CITY OF VANCOUVER

POLICY REPORT DEVELOPMENT AND BUILDING

TO: Vancouver City Council
FROM: Director of Planning
SUBJECT: CD-1 Rezoning - 5909-5989 Oak Street

Sheet No: **1/16" SITE PLAN**

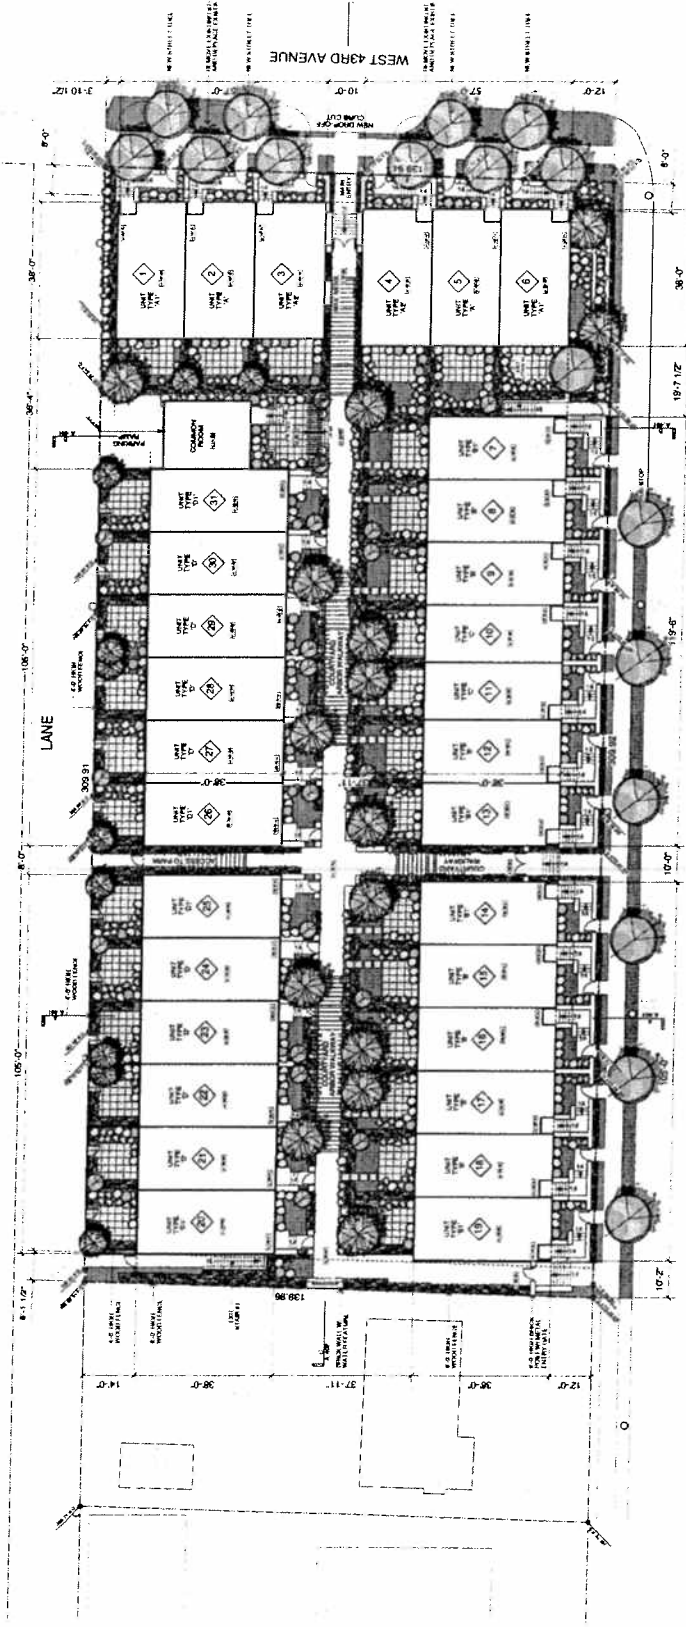
1. The northwest units (#20-25) do not appear to meet the intent of subsection 3.2.5.5 of the VBBL in that the travel distance to the principal entrance of these units exceeds 45 m.
2. The CACF for this site is to be located within 100 m of a City Fire Hydrant per new VBBL.
3. The VFERS do not consider a City lane as an acceptable access route, therefore access to units #20-31 via the lane is not acceptable per A-3.2.5.6. (1) VBBL.
4. The access routes must meet the intent as defined in A-3.2.5.5. (1) VBBL.

5. There must be a City hydrant located within 100 m of each principal entrance of this site. There is no indication of a City hydrant on the submitted plans. If a City hydrant cannot be provided, there must be a private hydrant so that service to the site is acceptable.
6. The units off of Oak Street must meet the requirements of A-3.2.5.5. (3) VBBL.

Several members of the Panel suggested having a double row of trees on Oak Street.

Several members of the Panel suggested moving the lane units back from the lane to give them larger yards. They also suggested adding paving and planting to improve the presentation of the lane as a primary entrance and to visually connect the site to the park.

The Panel felt the continuous trellis might be a little heavy and suggested breaking it up a bit to bring more light into the courtyard. The circulation nodes in the courtyard plan could also be more clearly emphasised.

- (ii) Design development to improve the public realm interface along Oak Street, providing a second inner row of trees inside the property line.

Note to Applicant: A second row of trees is to be located inside the property line, providing a three foot clear width. Consider realigning entry stairs perpendicular to the main entry doors to achieve sufficient spacing for trees.

- (iii) Design development to the lane edge conditions, providing a layered landscape border and improving the orientation and visual connections of the rear facing townhouses towards the lane and the park.

Note to Applicant: Provide at the lane edge a three foot landscape setback with a raised curb edge, a continuous row of trees and low level pedestrian lighting. Fences should be located inside, to the east of the landscaped setback, with gated entries and specialty paving. The width of the inner courtyard may be reduced slightly to achieve these objectives.

- (vi) Design development to the landscape courtyard, creating areas of special interest and focus, providing more variety and opportunities for social interaction.

Note to Applicant: The trellis element should be broken up into smaller, less continuous sections, allowing for more openness and views to the sky. Provide areas of special focus with bench seating and a water feature.
